DATE REVISED	DATE REVISED	FED.RD. DIST.NO.	STATE	JOB NO.	SHEET NO.	TOTAL SHEETS
10/19/2026		6	ARK.	110812	2	107
		INDEX OF SHEETS AND STANDARD DRAWINGS

SCHEDULE OF BRIDGE QUANTITIES
HWY. 49 MISSISSIPPI RIVER BRIDGE REHAB. (S)
PHILLIPS COUNTY
ROUTE 49 SECTION 11
ARKANSAS STATE HIGHWAY COMMISSION
LITTLE ROCK, ARK.

SUMMARY OF ILLUMINATION & ITS QUANTITIES
HWY. 49 OVER MISSISSIPPI RIVER
HWY. 49 MISSISSIPPI RIVER BRIDGE REHAB. (S)
PHILLIPS COUNTY
ROUTE 49 SECTION 11
ARKANSAS STATE HIGHWAY COMMISSION
LITTLE ROCK, ARK.
DRAWN BY: JR DATE: 11/2025 FILENAME: B110812_E1.DGN
CHECKED BY: DM DATE: 11/2025 SCALE: NOT TO SCALE
DESIGNED BY: DB DATE: 11/2025
BRIDGE NO. 02899 DRAWING NO.

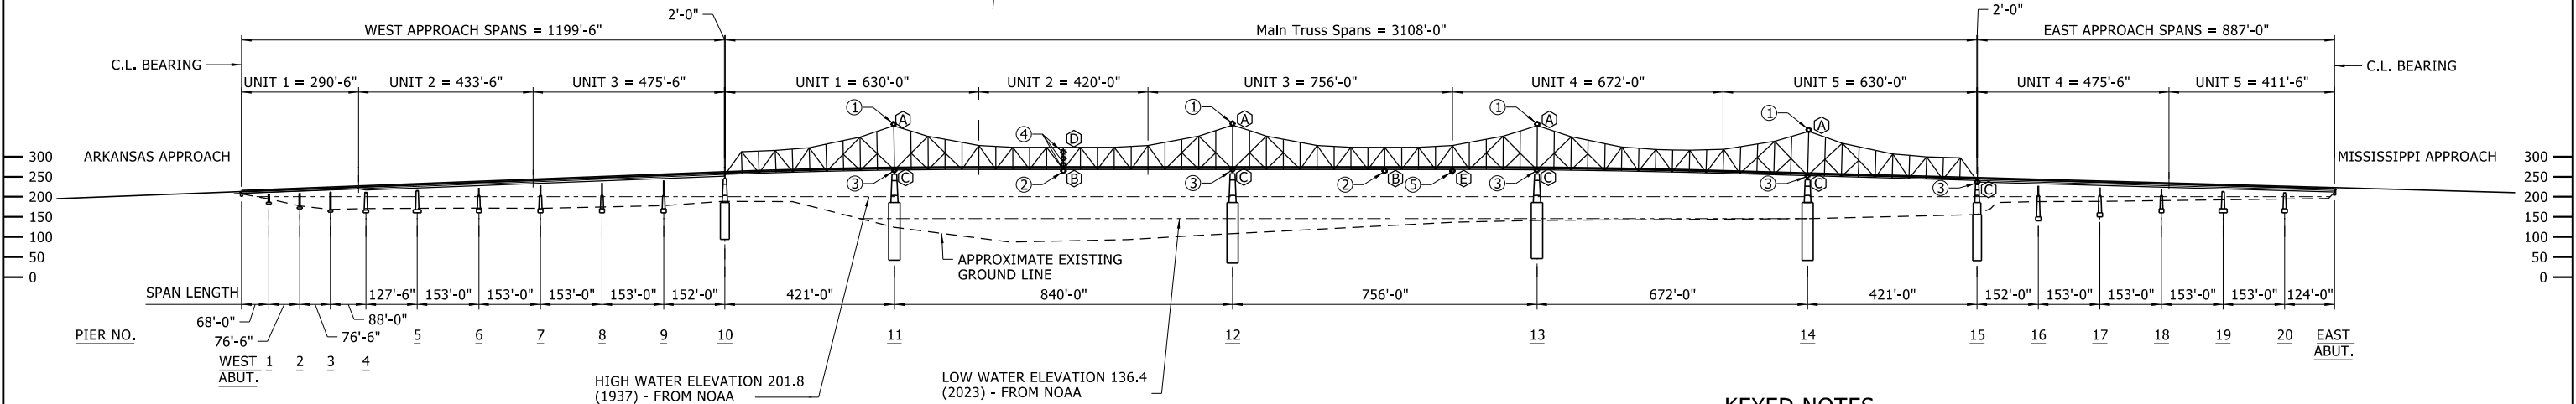
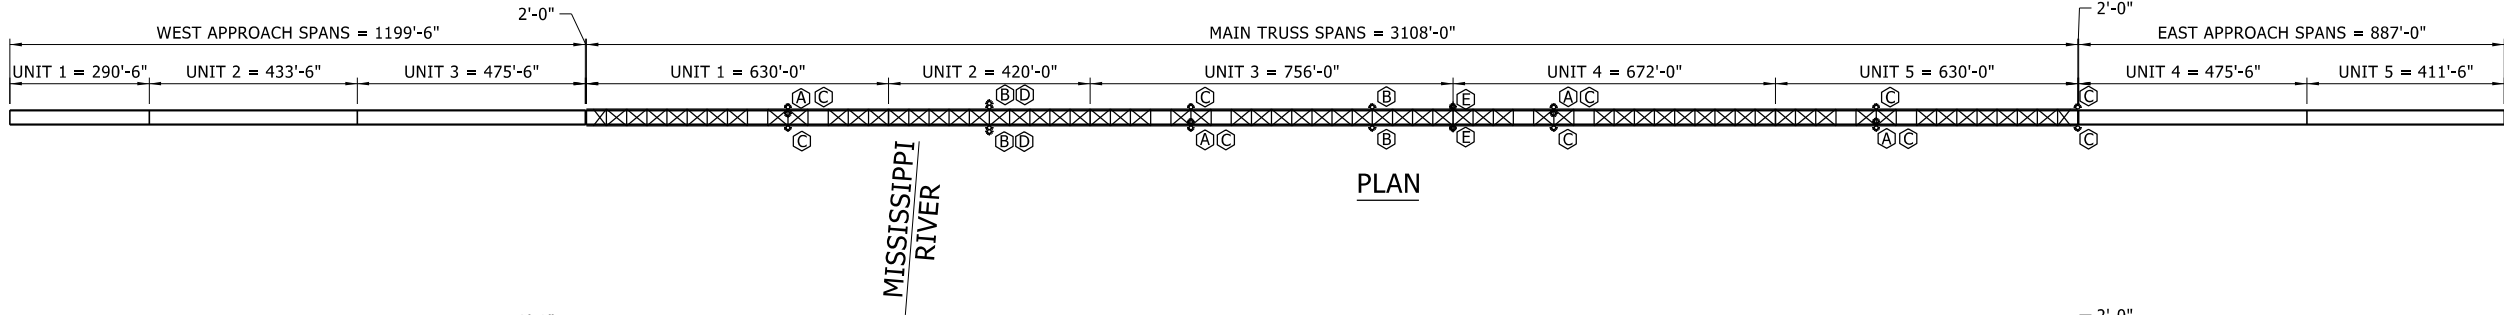
⚠ Revised Key Notes 1 through 4 to align with Summary of Quantities - Electrical table on sheet 31.
By: JJR 10/19/2026
Checked by: DIB 10/19/2026

DETAILS OF WEST ABUTMENT BACKWALL REPAIR ROUTE SECTION ARKANSAS STATE HIGHWAY COMMISSION

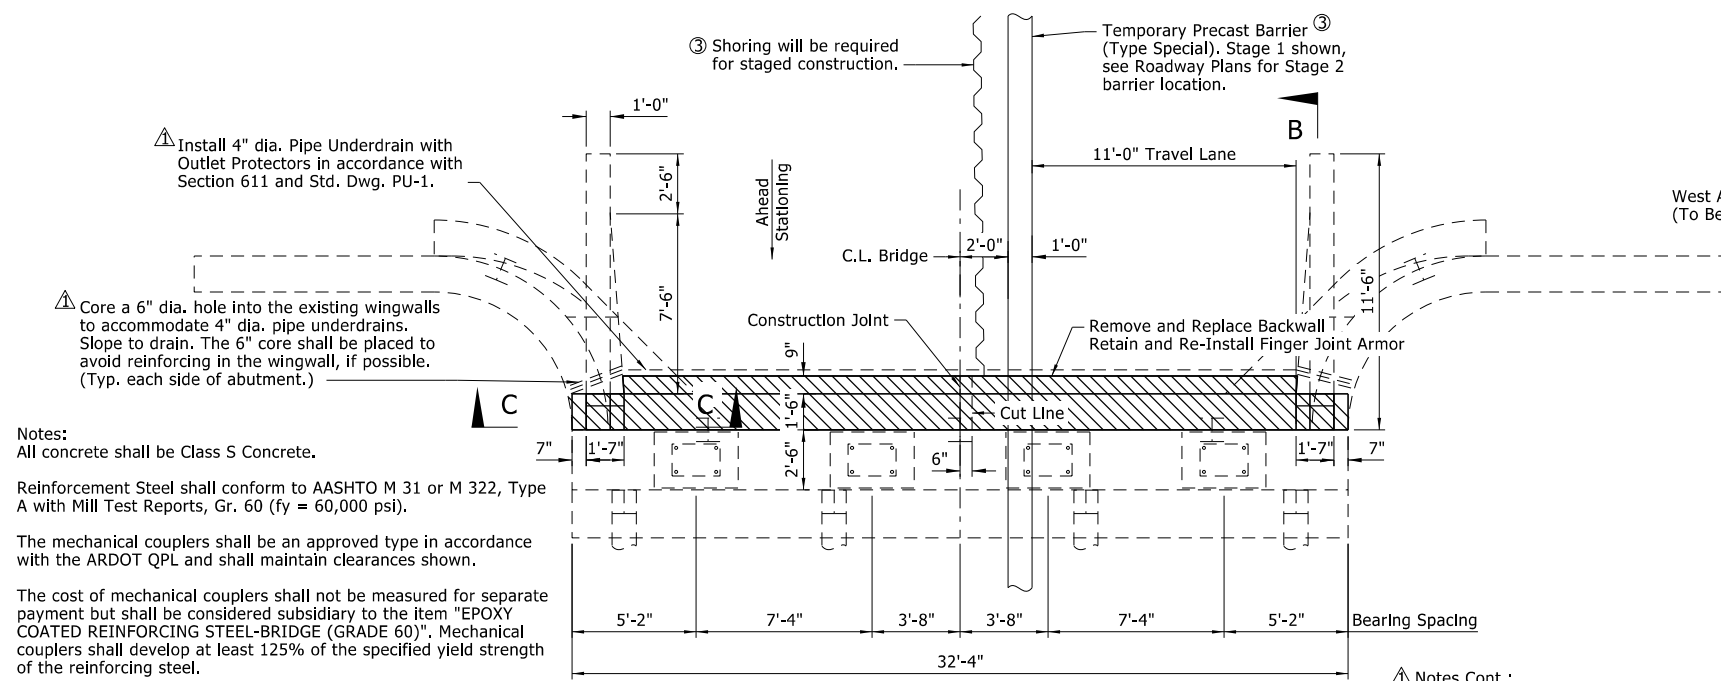
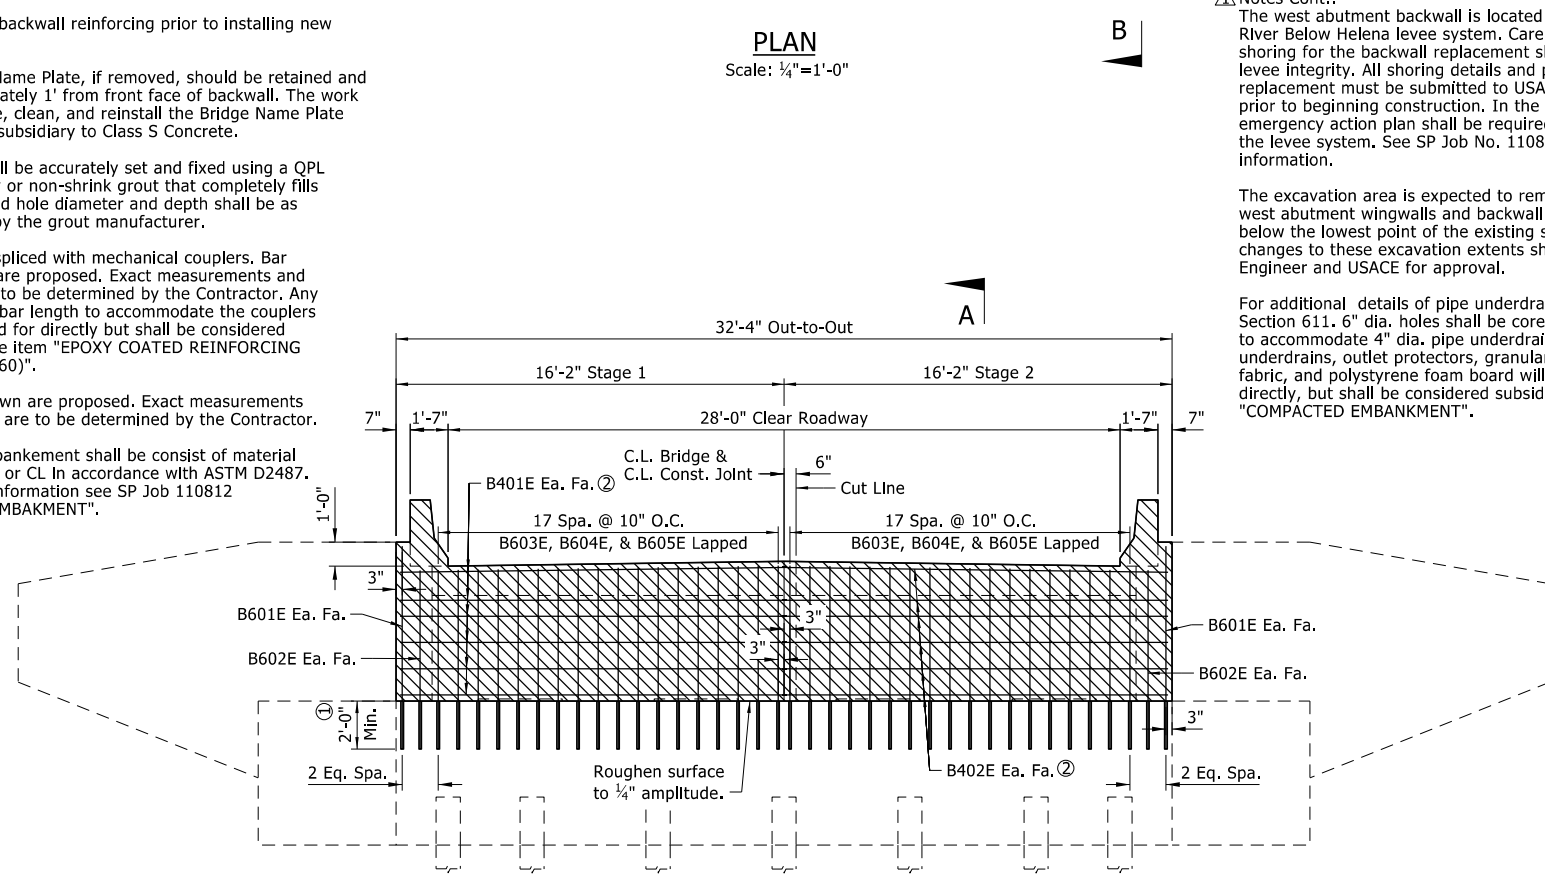
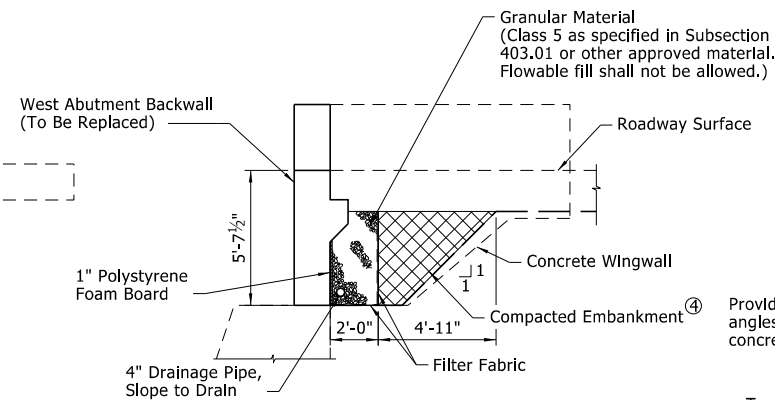
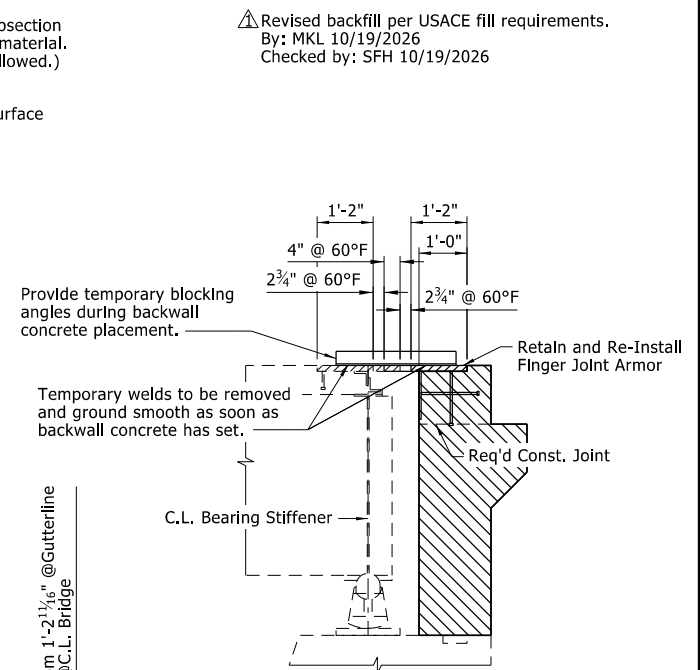
Revised backfill per USACE fill requirements.
By: MKL 10/19/2026
Checked by: SFH 10/19/2026

**SHEET 2 OF 2
DETAILS OF FLOOR BEAM REPAIRS:
REPAIR TYPE C -
WEB REPAIR**

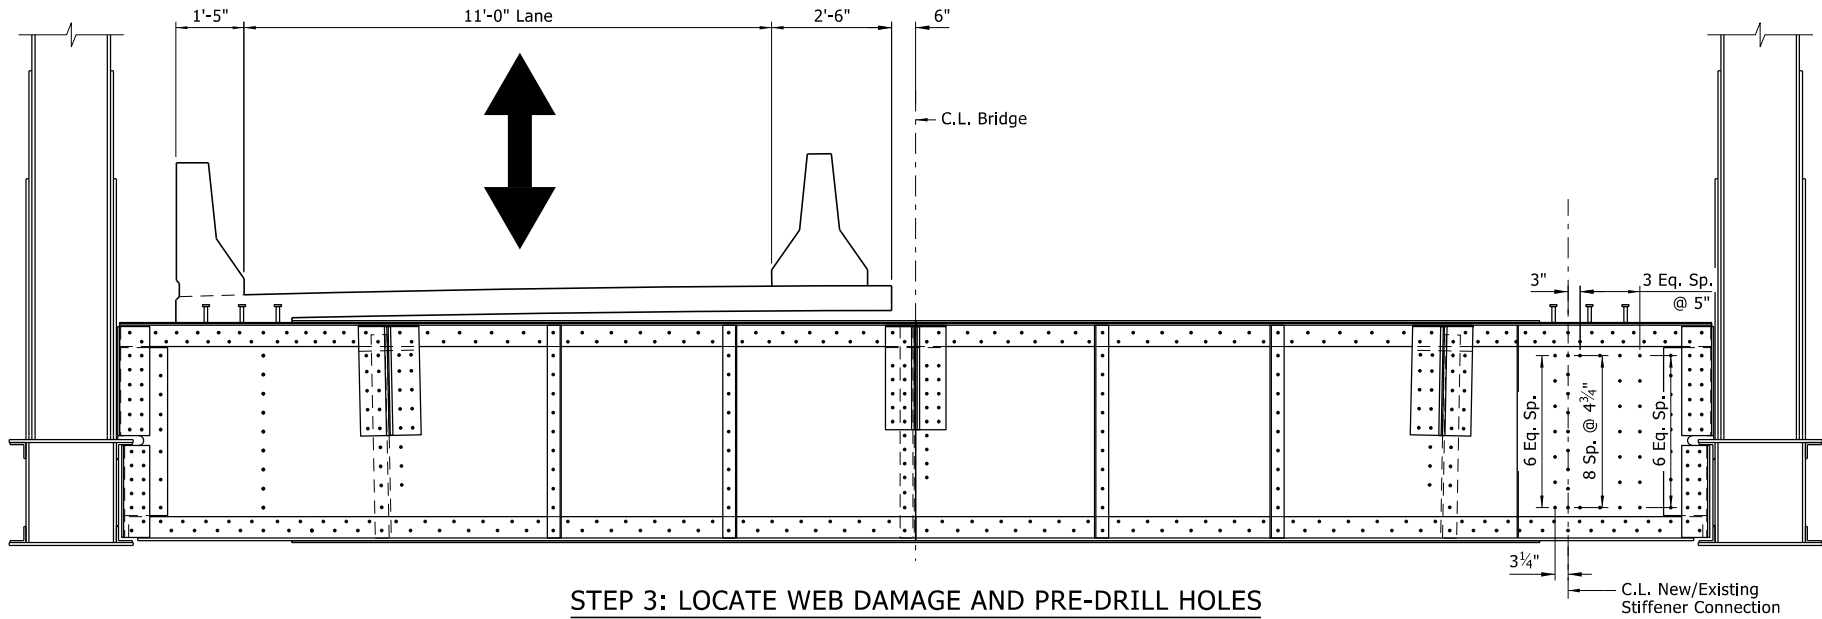
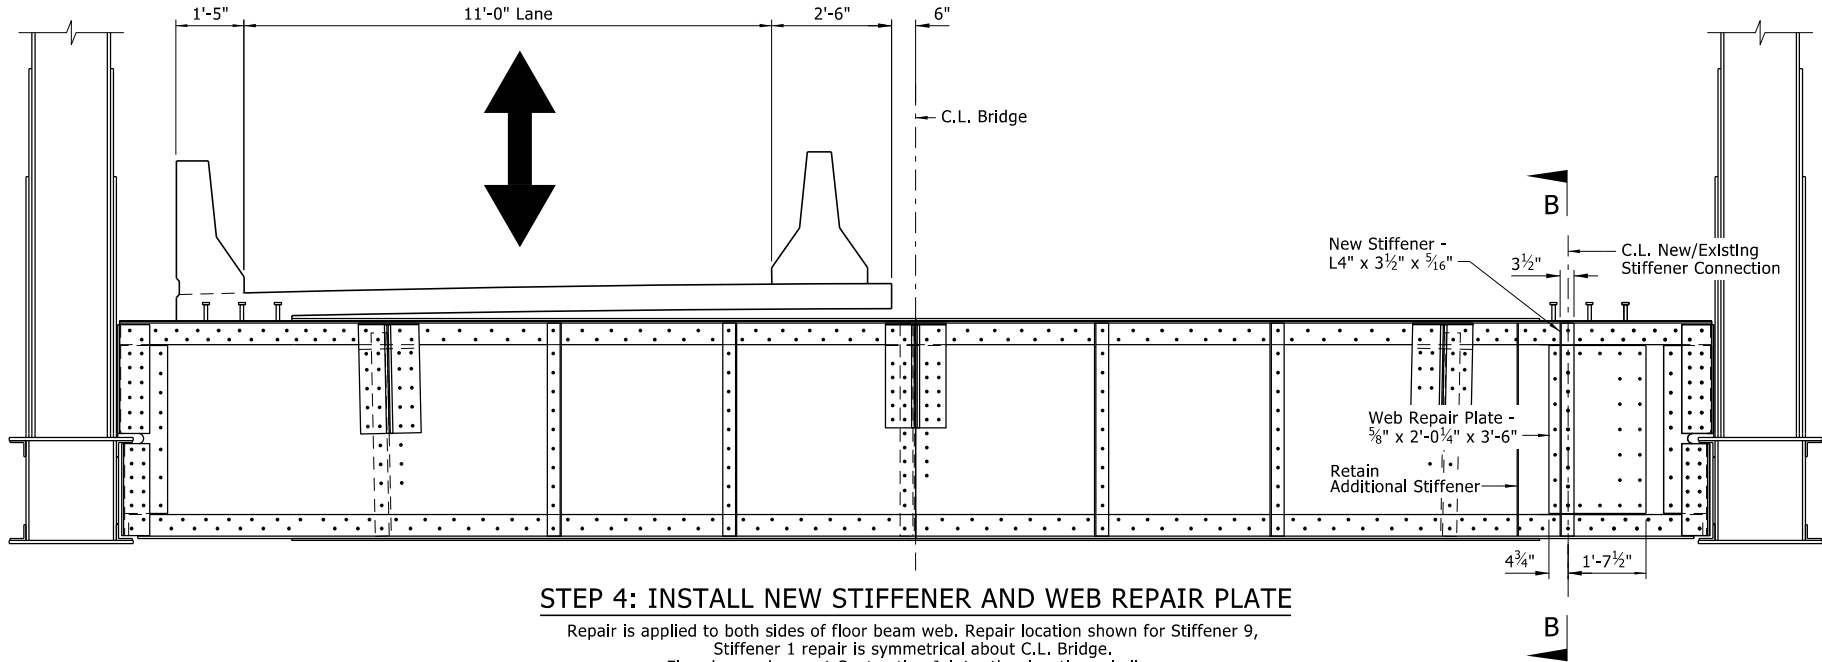
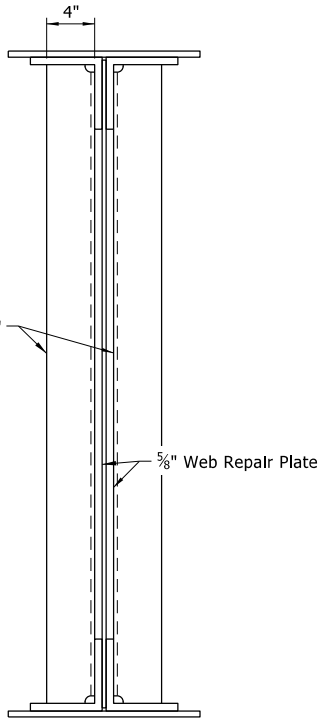
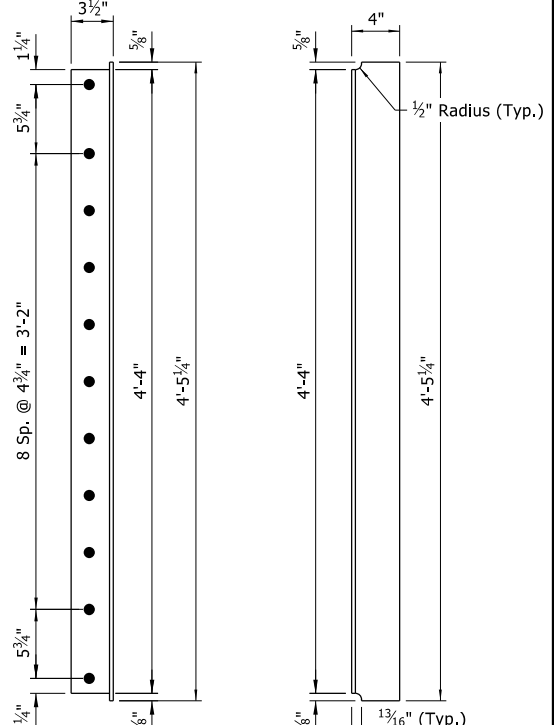
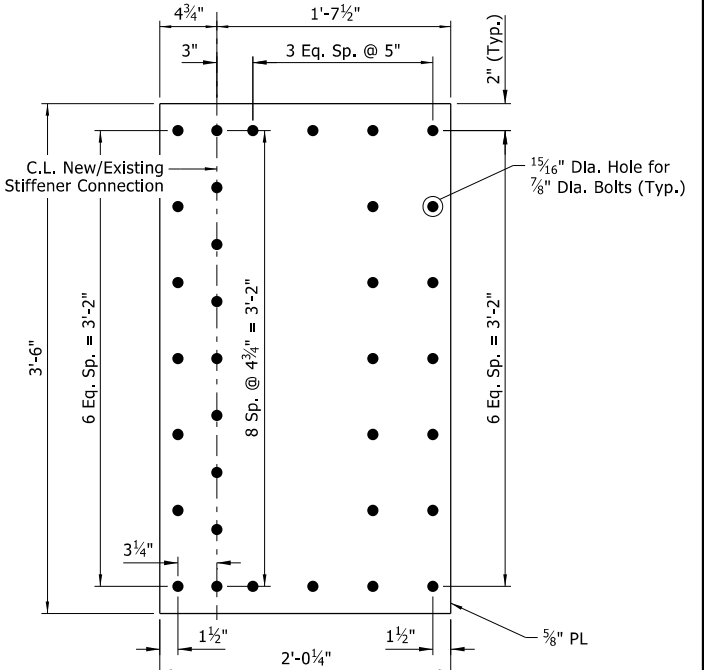
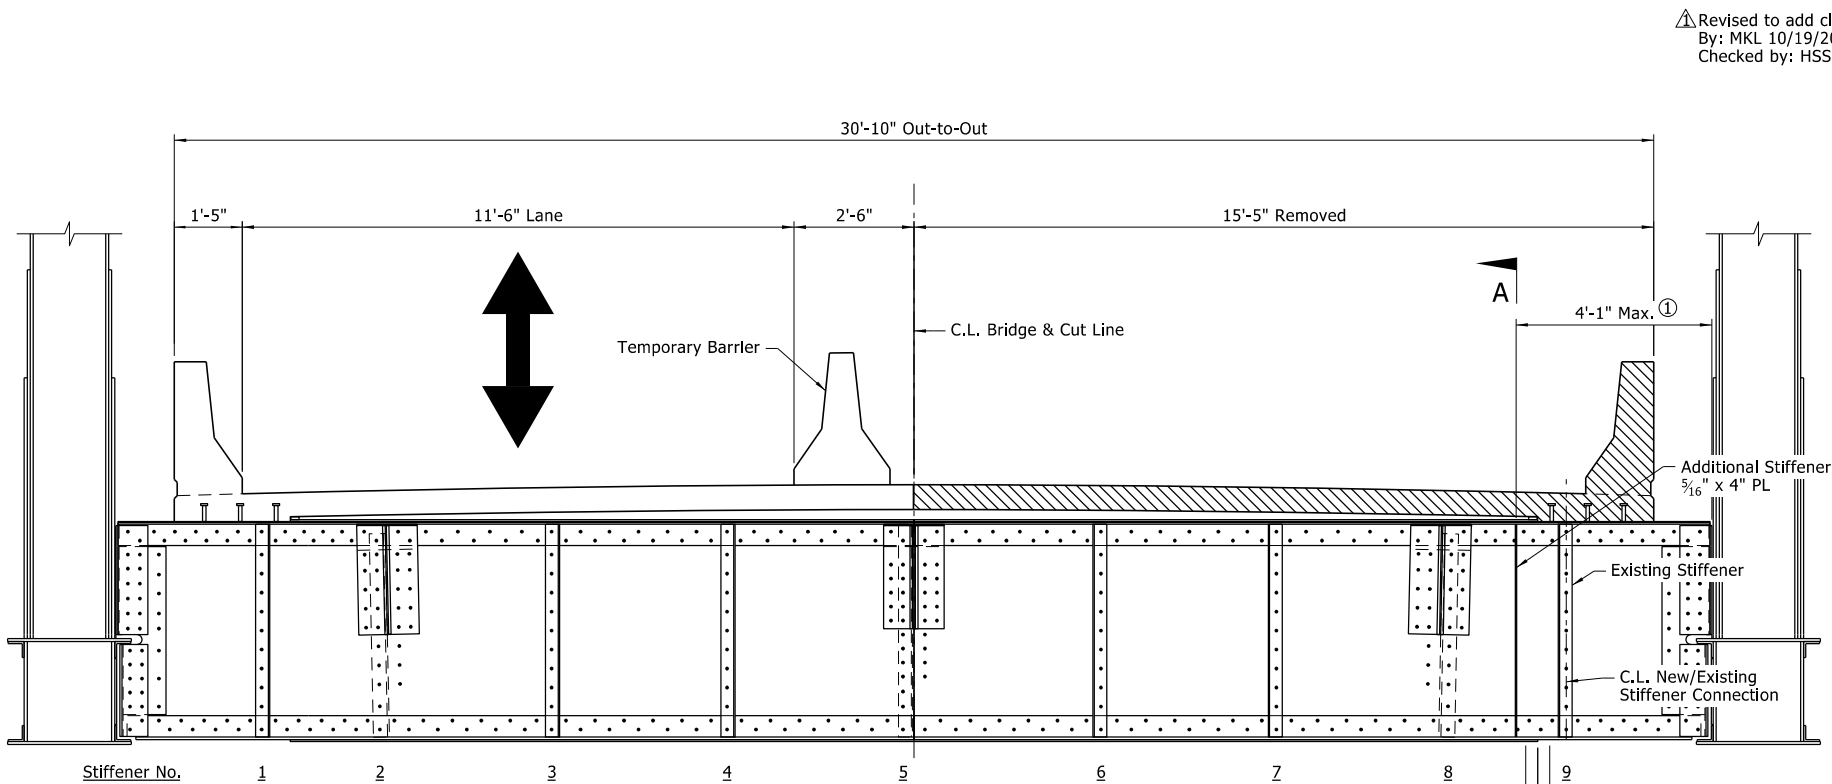
Revised to add clip for fit.
By: MKL 10/19/2026
Checked by: HSS 10/19/2026
